# FALCON2M

Project Code: 91.40R01.001

1. Modify Net error
  - a.CPU I/O deculping cap.
  - b.COM\_RI#\_5RSM & PME#\_5RSM
  - c.AC\_SDATA\_IN1 & ENSN#\_3RSM
  - d.SB +3VSB
  - e.HDD PID13,14
- 2.Add U34
- 3.Change CardBus controllor from Ti 1410 to Oz 6812  
Dummy R88
- 4.TC23 100uF/TC7 150uF
- 5.Del U24
- 6.Del CPU & DC/DC Gaps
7. Add XC? for IBM HDD -0.3V undershut voltage
- 8.Modify the USB circuit for cost-down
- 9.Change BC437 from 560 to 3300 pF for CRT  
jitter
- 10.Reserve TXC1 for CD-ROM undershut
11. SB for CD\_ROM pop  
noise
- 12.SB Del remainder BLL circuits

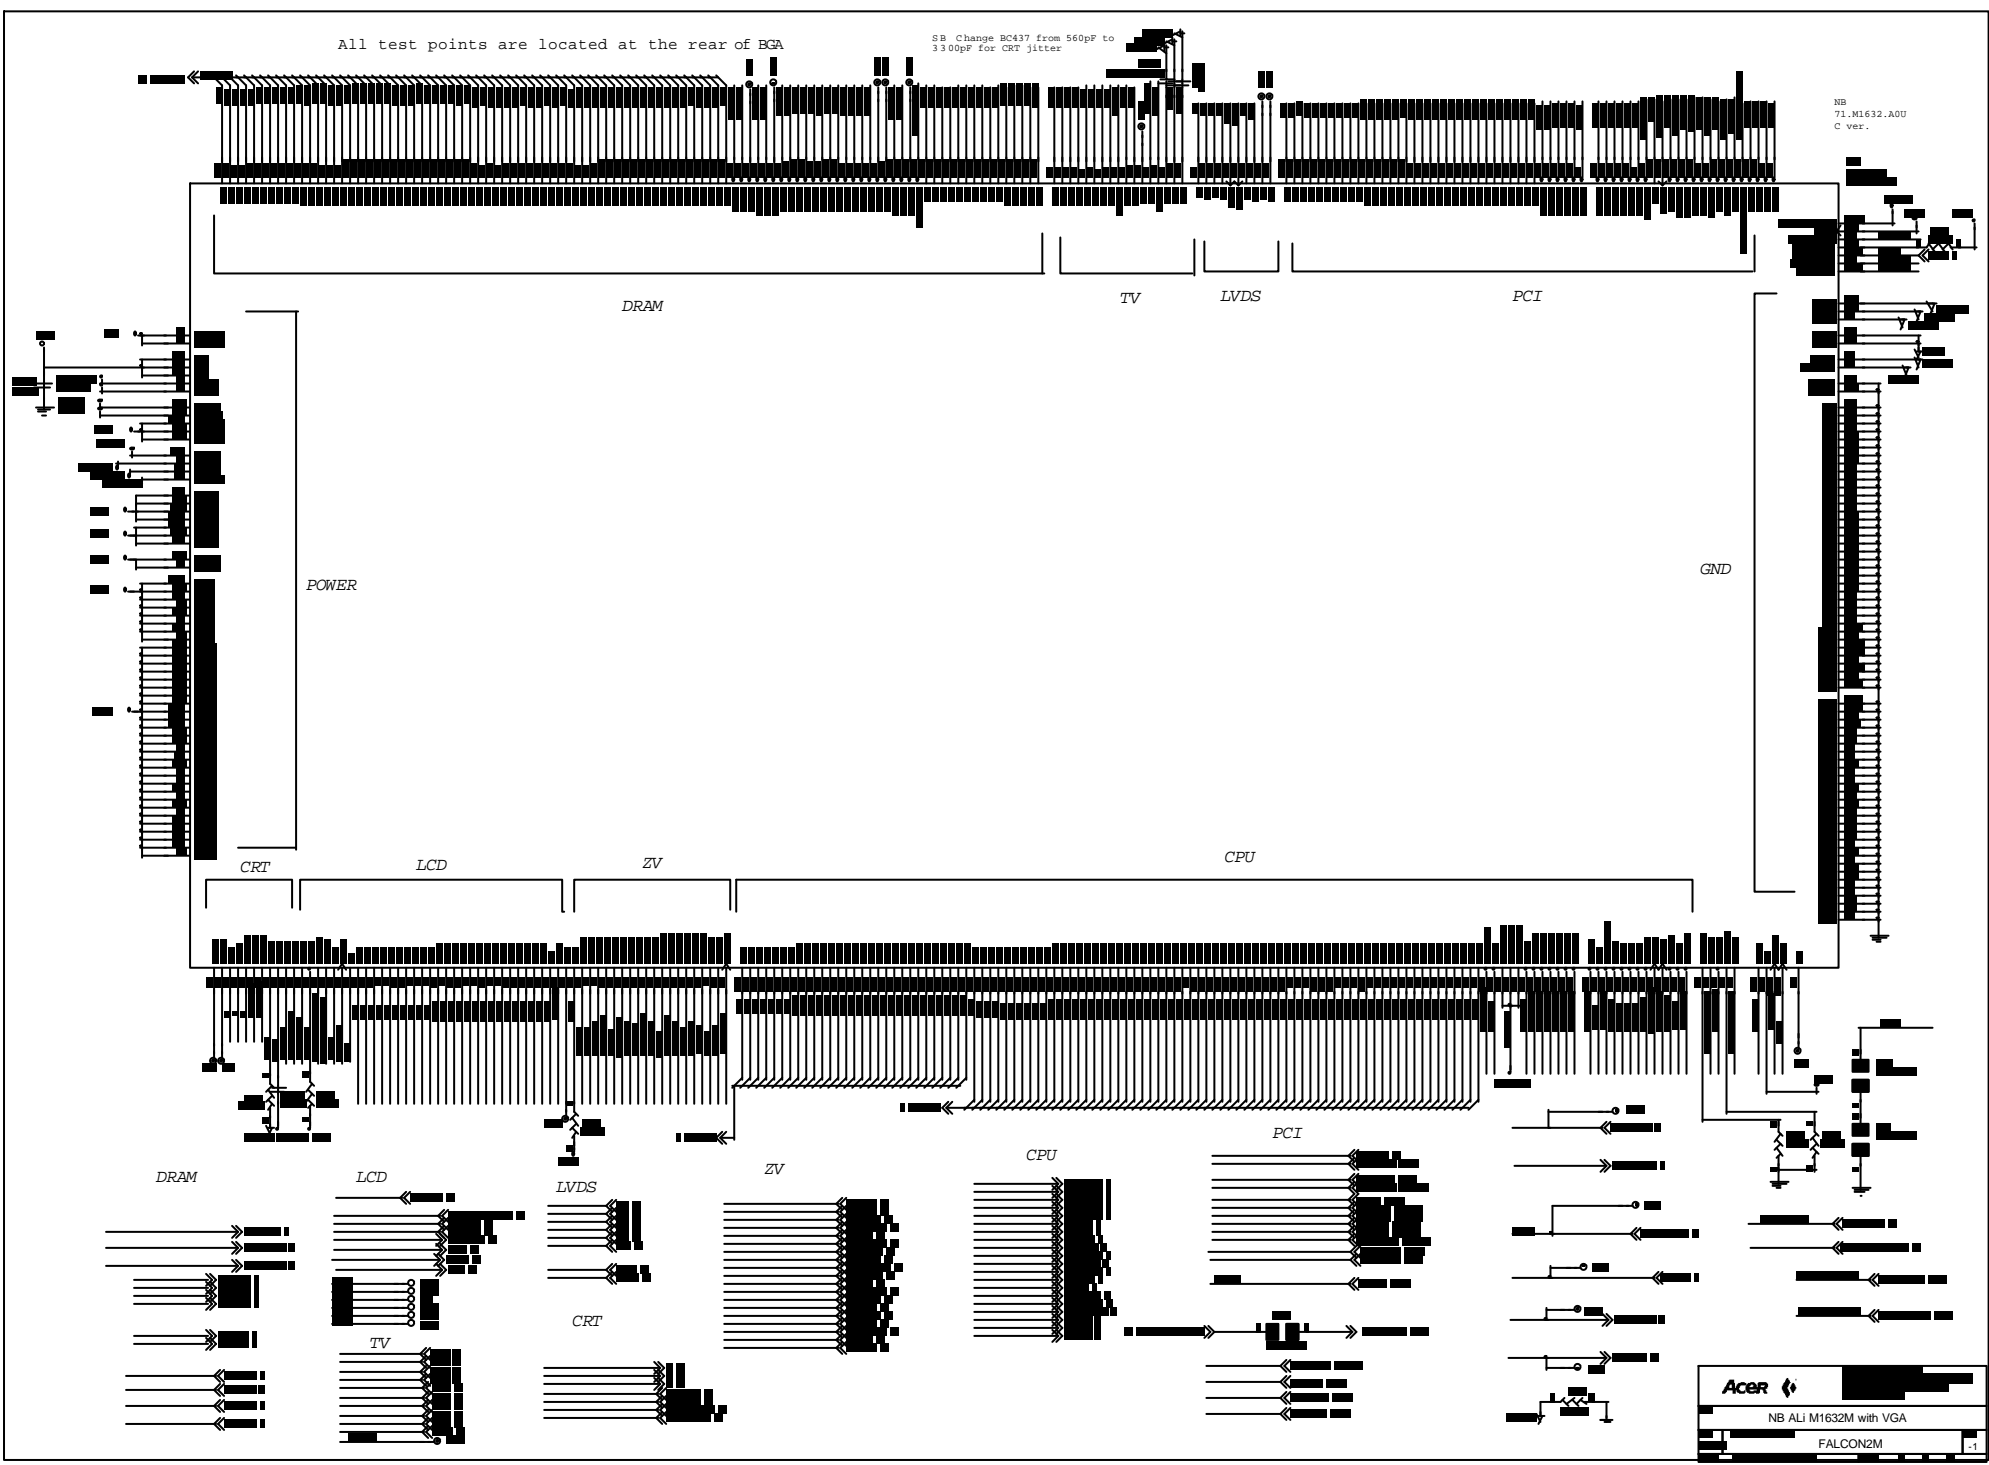
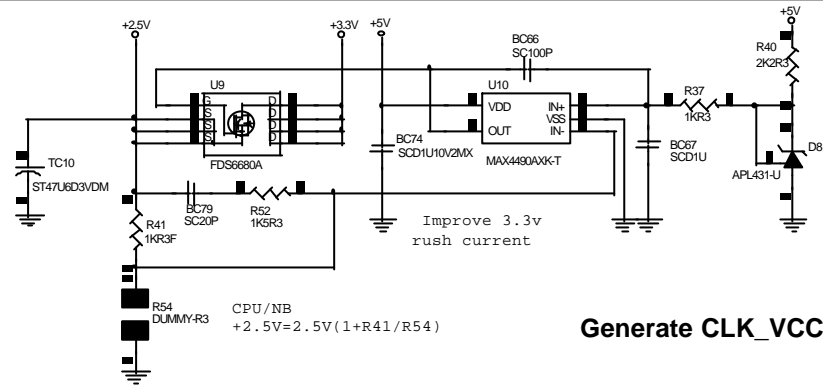
SB Change BC437 from 560pF to 330pF for CRT jitter

M1632 HARDWARE SETTING

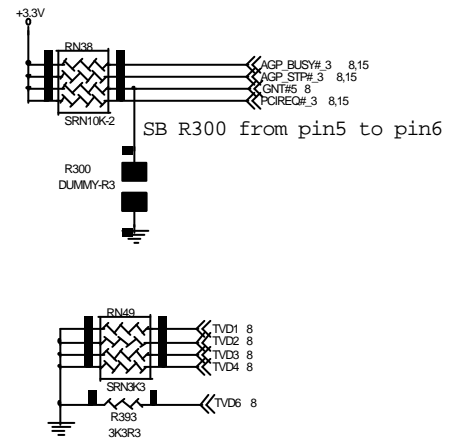
SB GNT#2 changed to "H" for improving timing

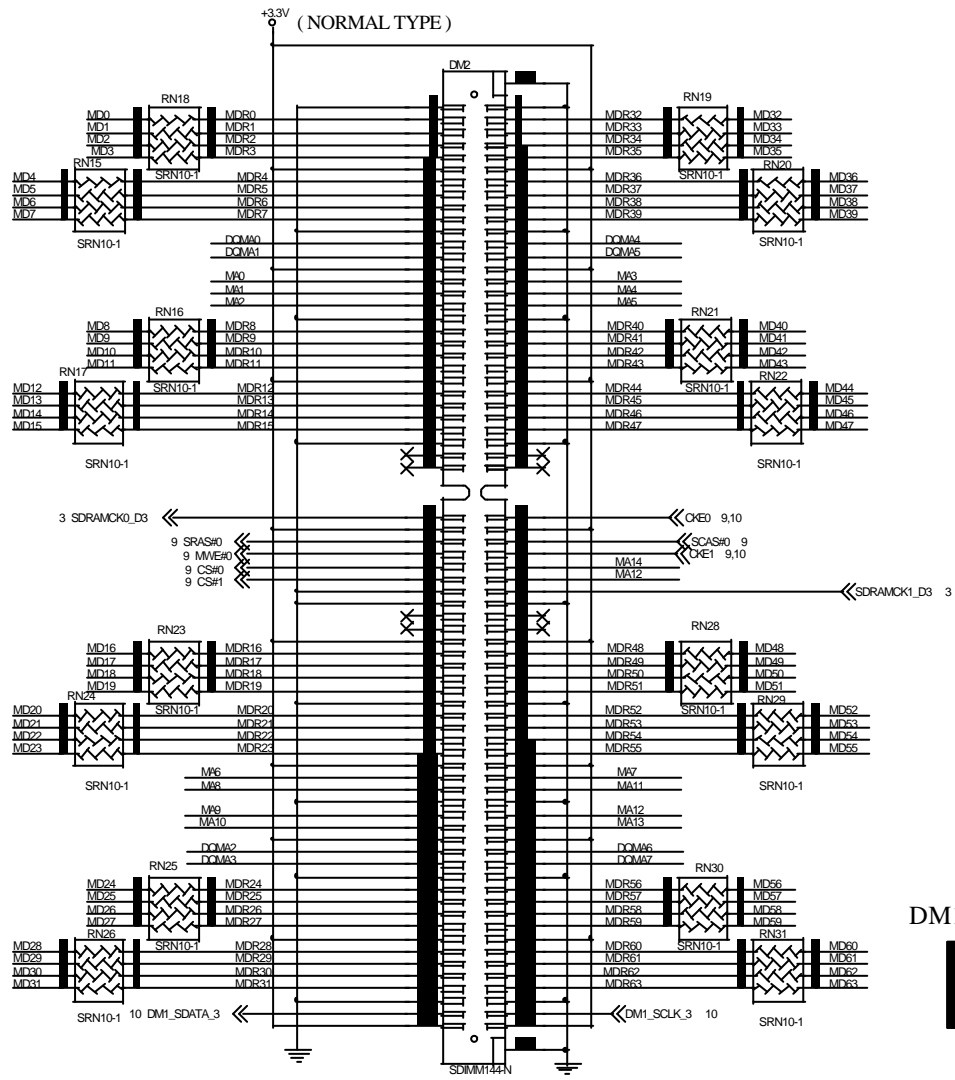
Change to AMP

# CDROM

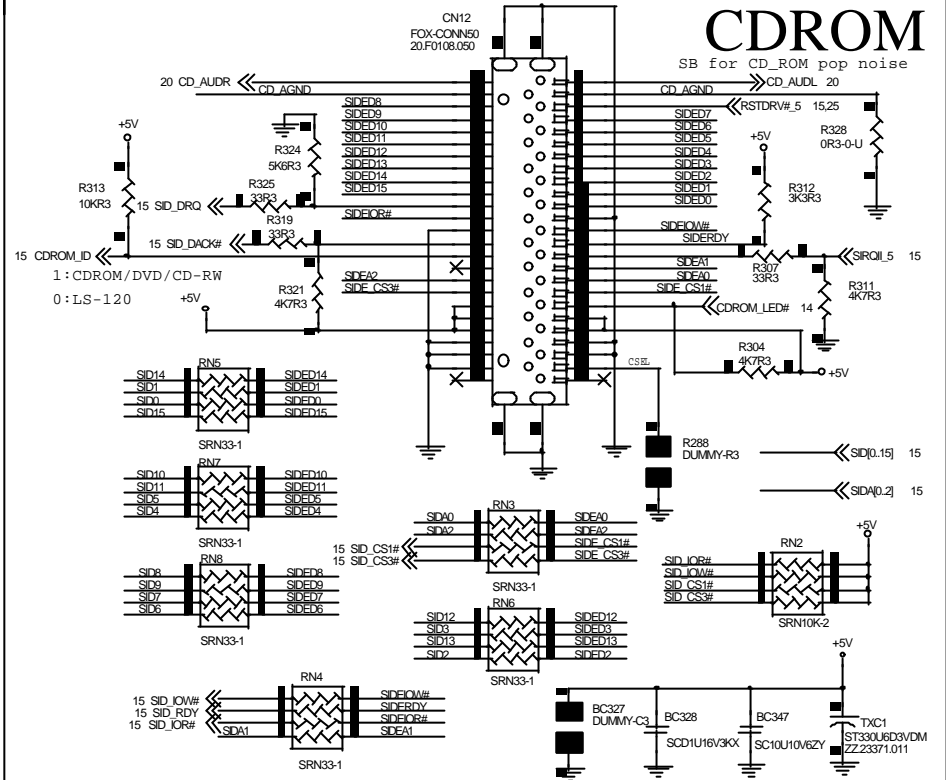
SB cost-down SB Reserve for undershut

# USB0

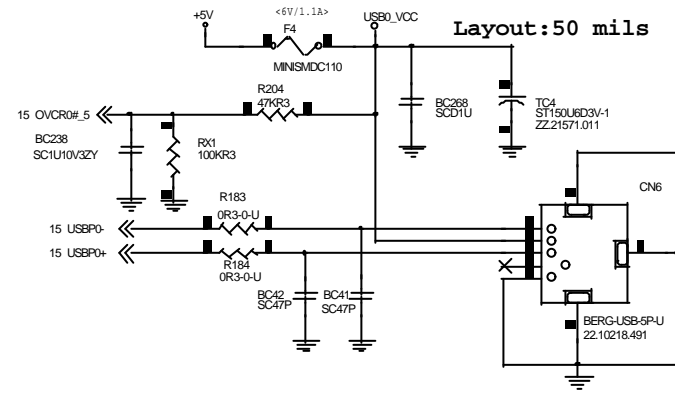
SB Cost-down USB circuit

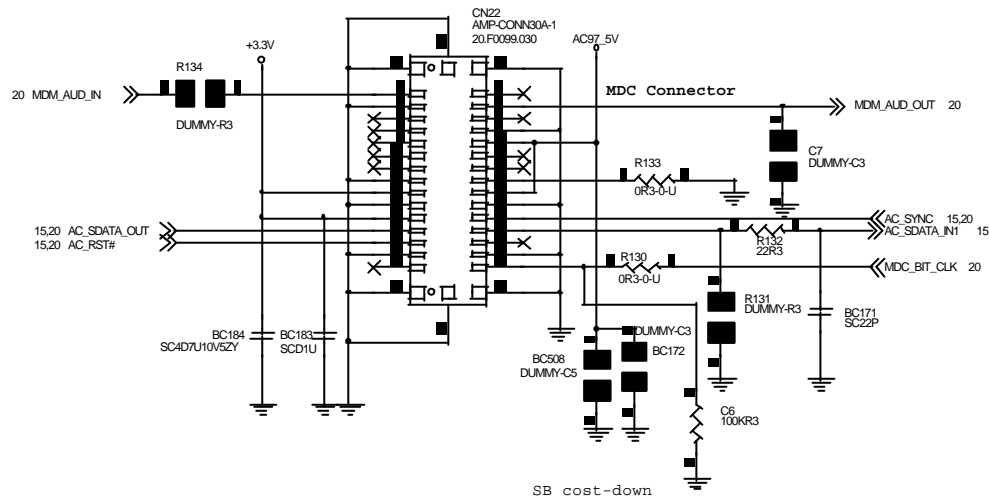
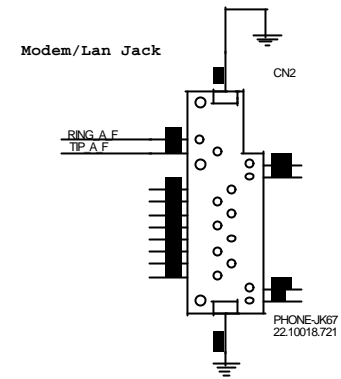
EMI  
SB Change R173/174 from bead to 0R3 by BOM

## FLASH ROM

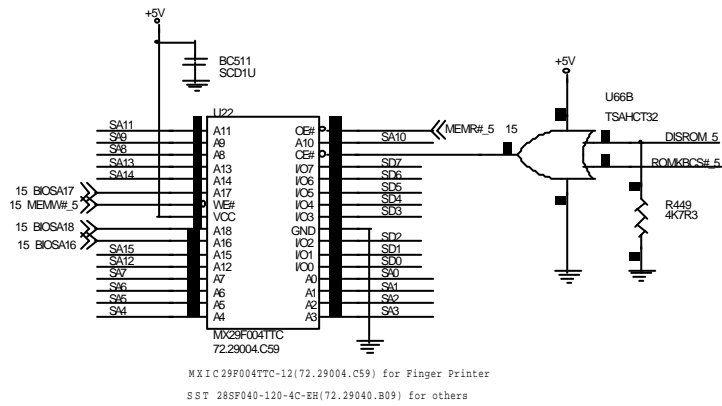
Change to 72.29004.C09 (B0N)  
not ready

## GOLDEN FINGER

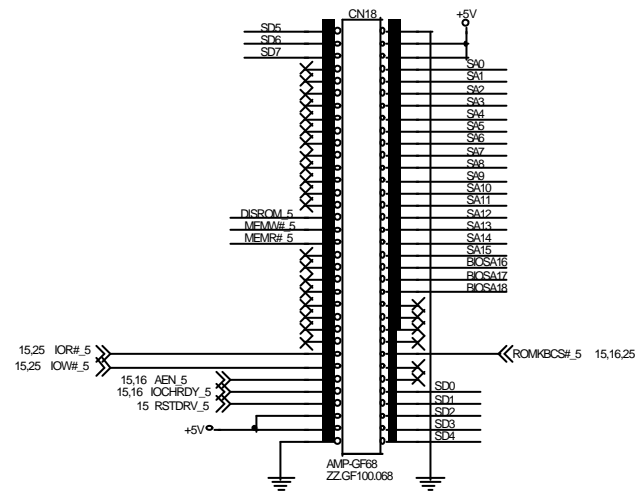
be change to AMP-GF68-A
